In accordance with Mr. Odegaarden's request in our telephone conversation of August 18, 1978, we hereby resubmit our referenced request for amendment to USNRC Certificate of Compliance No. 6698, Revision 7. The requested amendment will change references to NFS Drawing No. 10080, Sheets 1 through 4, Revision 14 to NFS Drawing No. 10080, Sheets 1 through 4, Revision 16. In addition pages 3-99.1 and 3-99.2, attached hereto, will be added to the Safety Analysis Report For Nuclear Fuel Services, Inc. Spent Fuel Shipping Cask, Model No. NFS-4 (SAR). This change to the SAR will be indicated as Revision 2 dated September 25, 1978.

REVISION 2-ADDITIONAL
PAGES (dated 9/1/78) FOR
THE SAFETY ANALYSIS REPORT
FOR NUCLEAR FUEL SERVICES INC.
SPENT FUEL SHIPPING CASK
MODEL NO. NFS-4 (dated 12/30/71,
updated 9/29/72)

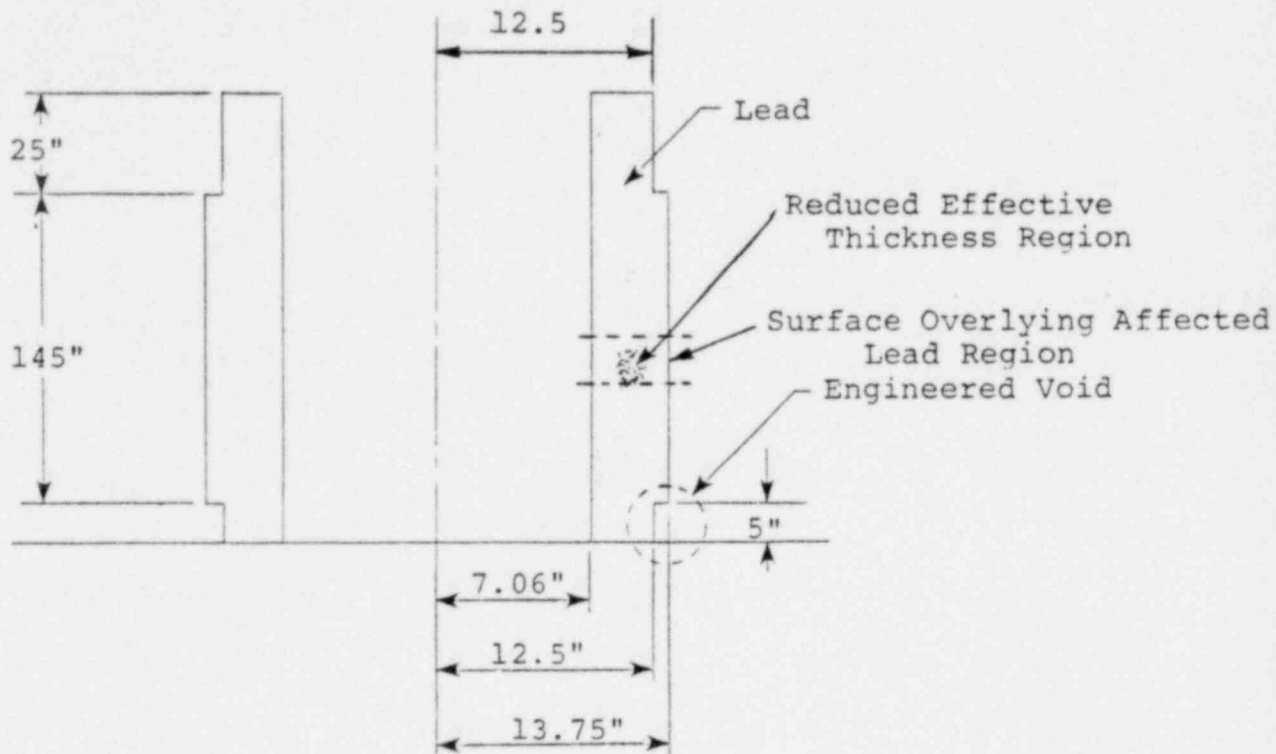
In addition to the engineered lead void provided at the base of the cask, there may be small regions of reduced effective radial thickness within the lead shield. This reduced effective thickness will not impair the structural or thermal performance of the packaging in an accident or other conditions prescribed by the regulations.

Assumption: Reduced effective thickness lead compresses under high deceleration loads.

In section 3.1.6.1.4.4.1 the end lead void resulting from deceleration forces was computed to be 0.315 inches. The maximum permitted length of end void is 1.0 inches. To assure conservatism this analysis uses 0.88 inch as the permitted length of lead void at the cask ends.

Therefore, the additional end void length which may result from compression of the reduced effective thickness region = .565 inches

Lead pour experience has shown that reduced effective thickness regions in free-poured lead are localized and easily detectable by non-destructive examination techniques. Accordingly, it is assumed here that the surface area of the heavy metal shield under which such regions may exist is no more than two and four tenths (2.4) percent of the cylindrical surface area of the 1½ inch steel shell. The volume of the lead under this localized area is approximately:

The allowable average percent reduced effective thickness in the lead shield in the localized region = $\frac{V_{\rho}}{V_{\text{lead}}} \times 100$

Hence total lead slump in the cask = $0.315 + .565 = 0.88 < "1.0"$
which is less than the one inch allowable specified in section 3.1.6.1.4.4.1.
